# Product Change Notification

<b>Date Issued :</b>	March 18, 2022	<b>PCN Number :</b>	511762
<b>Reason for Change :</b>	Change to Product Capacity change or tool replacement		
<b>Description of Change :</b>	This notification is to inform you about changes that are being made to the part(s) as identified in the list based on the replacement of aged tooling. This change will not affect the Fit, Form or Function of the product but Will affect the Appearance of the product at the Locking Latch location.		
<b>Assessment of Change :</b>	First Article Inspection		
<b>Planned Implementation Date :</b>	September 30, 2022		
<b>Sample Availability Date:</b>	August 19, 2022		
<b>Internal Molex Qualification Date :</b>	August 05, 2022		
<b>Last date to request Samples by Customer :</b>	September 23, 2022		
<b>Traceability Code Markings / Date :</b>	Cavity identification

- **5557 Series**
- Mini-fit JR 3ckt receptacle

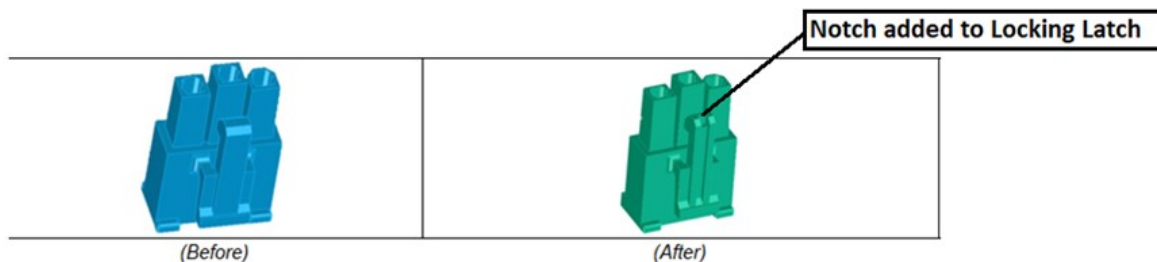
- To ensure business continuity, Molex Lincoln Nebraska is needing to replace tooling for the Mini-Fit Jr 3ckt receptacle due to the age of the current tool.
  - New tooling will be changed to improve mold flow during part production
  - Product from the New tooling from Lincoln Nebraska will have a notch added to the Locking Latch
    - Notch in Locking Latch is to improve mold flow and reduce short fill of product
    - Product made from other locations will not have this notch
- Change will impact Appearance of the part at Locking Latch location
- There will be NO change to the Fit, Form or Function of the parts
- Part Numbers Impacted
  - See attached list
- Qualification and Samples available upon request after date shown above
  - Last date for sample requests will be September 23, 2022
